# TULLAMARINE CLOSED LANDFILL ANNUAL COMPLIANCE REPORT 2020

Presentation to Tullamarine Landfill Community Consultation Group

Mark Walker, Michael Stewart  
10/08/2021

## Q1) STORMWATER FLOW

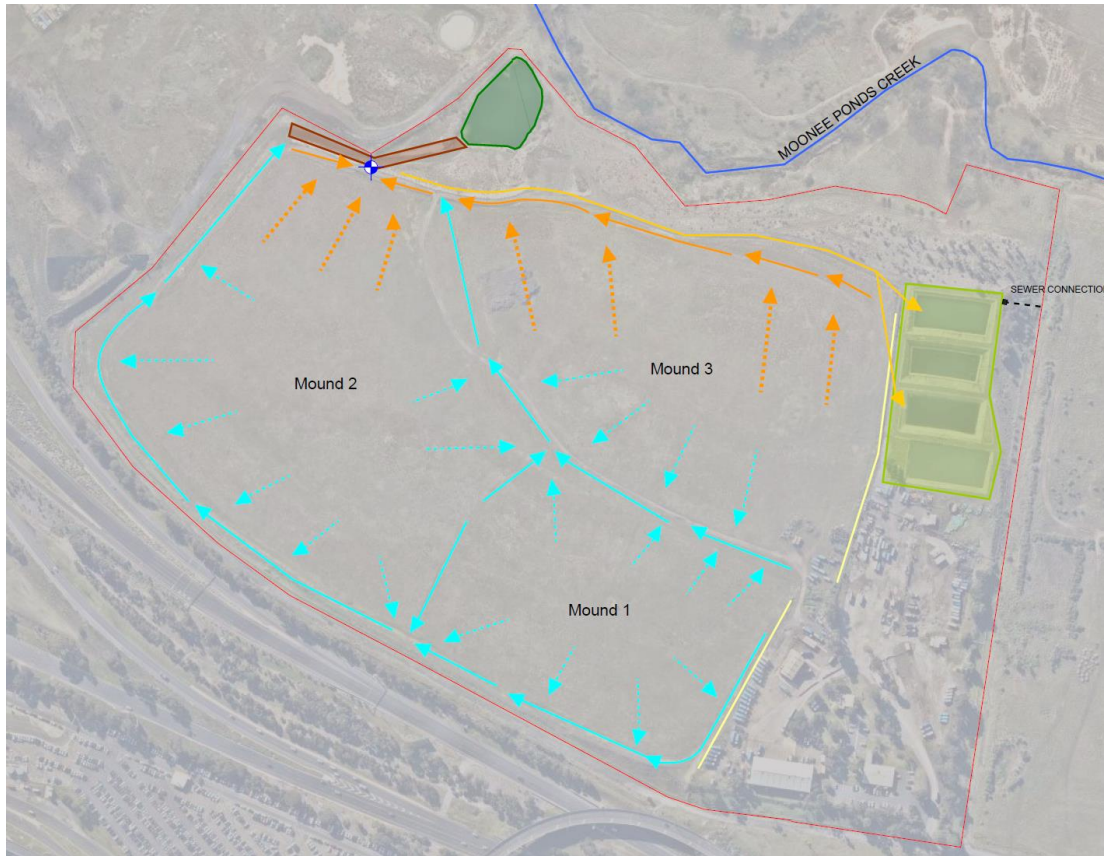
*Q1) On the linked report 2.3 Topography & Hydrology refers to 'The collected storm water (from the mounds) is directed to the rock pond...'*

*At the last meeting I asked a question concerning the 4 settling ponds/dams on the Cleanaway site & was advised that runoff from the mounds was directed to these settling ponds and used to water the mounds.*

*What is correct?*

*With the settling ponds/dams and what they have been used for in the past & now what if any testing has been done under these dams to check if they are not leaking/cracked or what substances/gases etc are present under them and are they harmful now or in the future.*

Both are correct. Stormwater at the site flows to the Rock Pond and the settling ponds, based on where the stormwater is collected on site.

This figure demonstrates that stormwater collected at the southern and western landfill perimeter (in blue) is directed to the Rock Pond, while stormwater collected at the northern landfill perimeter (in orange) is directed to the settling ponds.

As for harm, groundwater and landfill gas monitoring is undertaken at the site in the vicinity of the settling ponds.

Development on the buffer land would be subject to environmental assessment to determine risk and suitability.

# Q6) LEACHATE LEVELS

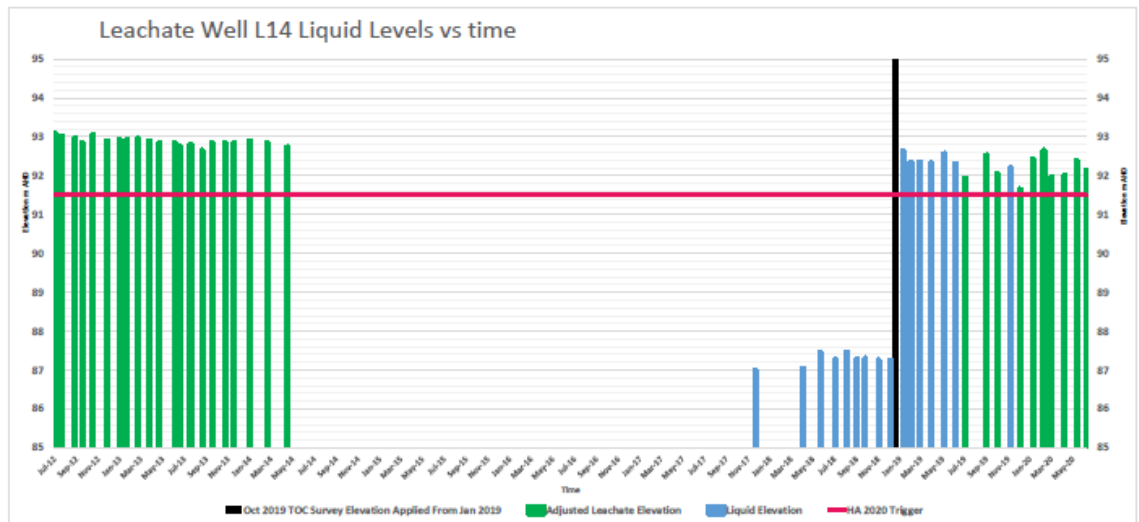
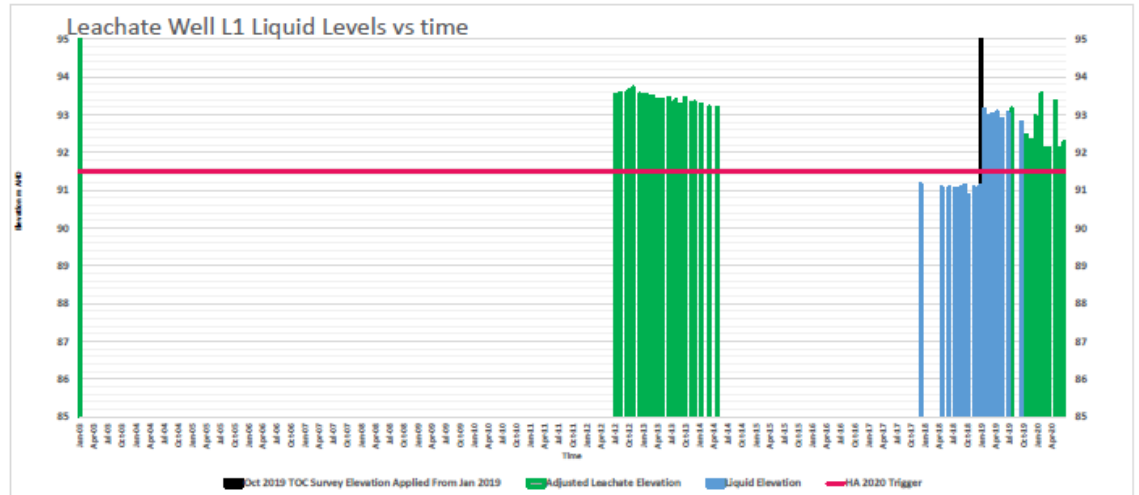
*Q6) How serious is the breaching of the Target Leachate Levels? Does this mean a pumping program to reduce levels and if so what happens to the leachate? Given the landfill is below the water table is this not a result of fluctuations in the water table or is it that the cap is allowing a greater ingress of rain water than it should?*

Leachate target levels were set for the site based on assumptions around how water levels would change over time.

What we are now seeing is that conditions within the landfill are changing at a slower rate than first thought. This has resulted in target levels continuing to be breached.

These charts (taken from the 2019 Audit report) show the liquid levels in two of the sumps (L01 and L14). The data gap between mid 2014 and early 2019 is due to an issue with the survey elevation for the sumps.

The data demonstrate a slowly decreasing trend. The breaching of target levels is not suggesting that leachate levels have increased. Leachate levels have always been above the target levels.

However, there are current investigations underway (Trend Assessment and a Hydrogeological Assessment) to investigate any implications of the slower than expected level decrease.

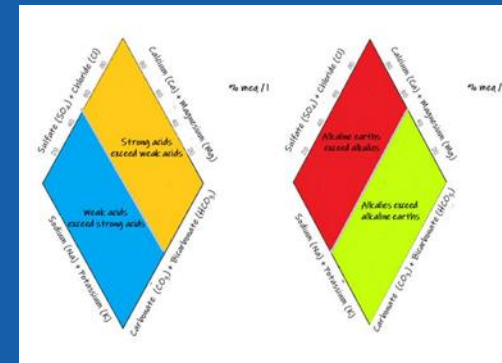
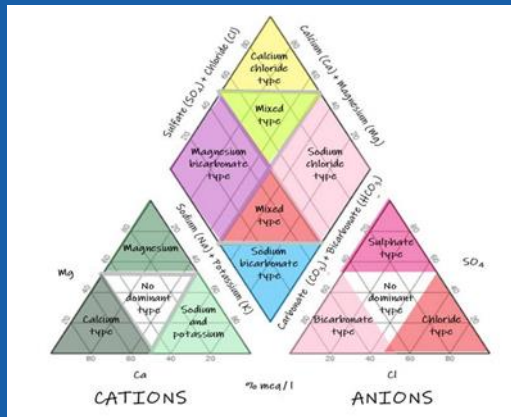
Q7) *Would it possible to get a simple plain language explanation or presentation of how Piper Diagrams work and how an expert would interpret such diagrams referring to the importance or otherwise of the coloured areas as per the diagrams below.*

## Q8) PFAS IN SURFACE WATER

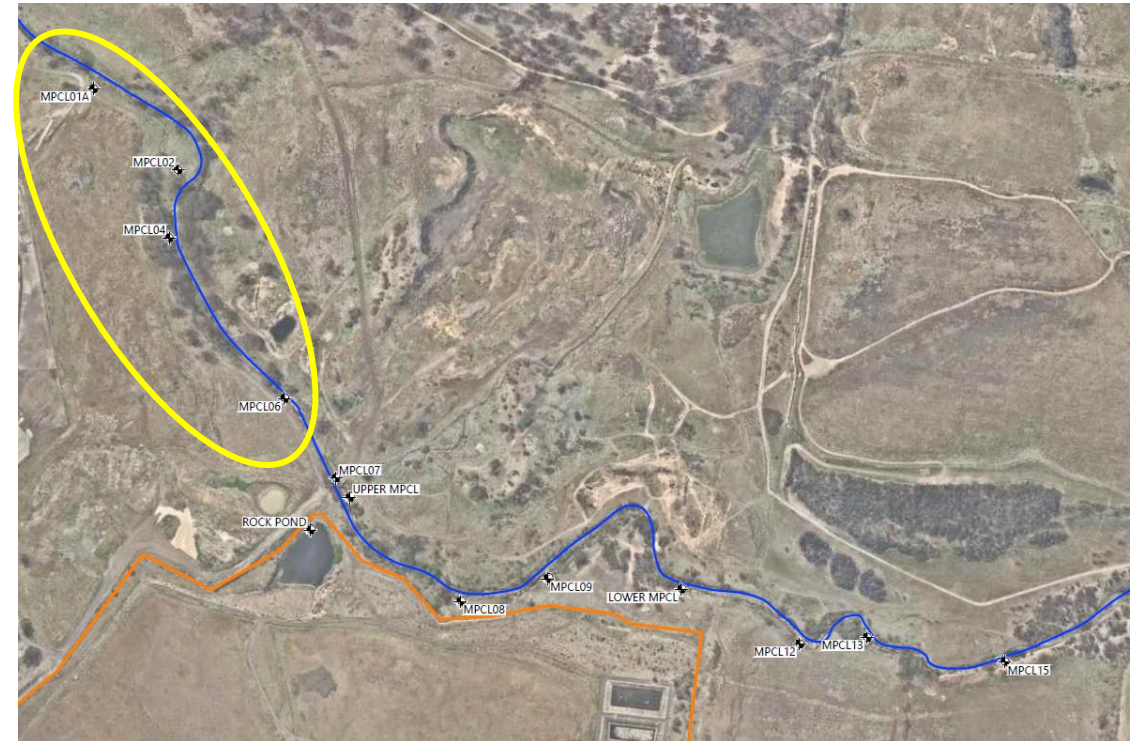
*Q8) PFAS was detected in surface water. Prima facie the source of the PFAS would be the soil used to cap the mounds but there may be other sources. Is there an explanation for the presence of PFAS in surface water? If the top soil is contaminated what action is being taken to rectify the situation?*

PFAS was detected in all surface water monitoring locations (which are along the Moonee Ponds Creek) over the reporting period. As previously presented, stormwater from the cap is captured in the Rock Pond and the settling ponds.

A number of these locations (circled in yellow) are upgradient from the site, indicating that the source of PFAS is likely to be upgradient from the site.

Assessing the source of a particular contaminant (especially one as widely used as PFAS, e.g. aviation, fire fighting) can be difficult for surface water as the contaminant can enter the creek via many different pathways (for example):

- Stormwater outlet drain from the airport.
- Overland flow from surrounding land (including the landfill).
- Groundwater emanating from below the airport, landfill and other land uses.

## Q9) METHANE IN PERIMETER GAS BORES

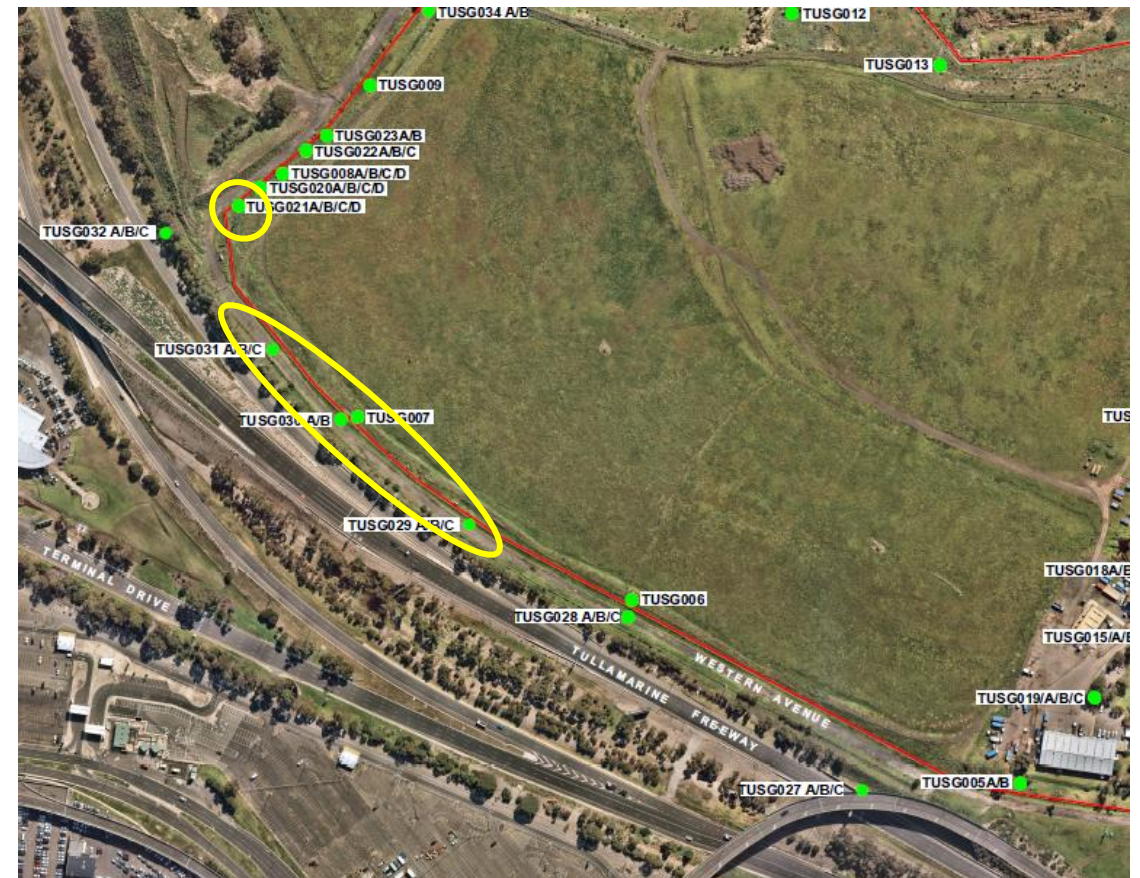
*Q9) The 2019 Post Closure Audit Report identified a number of perimeter bores that were too close to the Landfill mass for which it was recommend they be correctly located. Are the above bores from which methane exceedances were recorded those impacted by the 2019 report, ie are the bores listed above too close to the landfill mass or are the results from relocated bores?*

“TUSG08C/D, TUSG18A/B, TUSG20B/C/D, TUSG21C/D, TUSG22C, TUSG29B/C, TUSG30B, TUSG31B) exceeded the action level of 1% v/v on one or more occasions. These boundary bores with exceedances are located on the eastern, southern and western boundaries.”

Of these bores, TUSG08C/D, TUSG18A/B, TUSG20B/C/D, TUSG22C were too close to the landfill mass.

The remainder (bores TUSG21C/D, TUSG29B/C, TUSG30B, TUSG31B) are on the southern boundary of the site (circled in yellow).
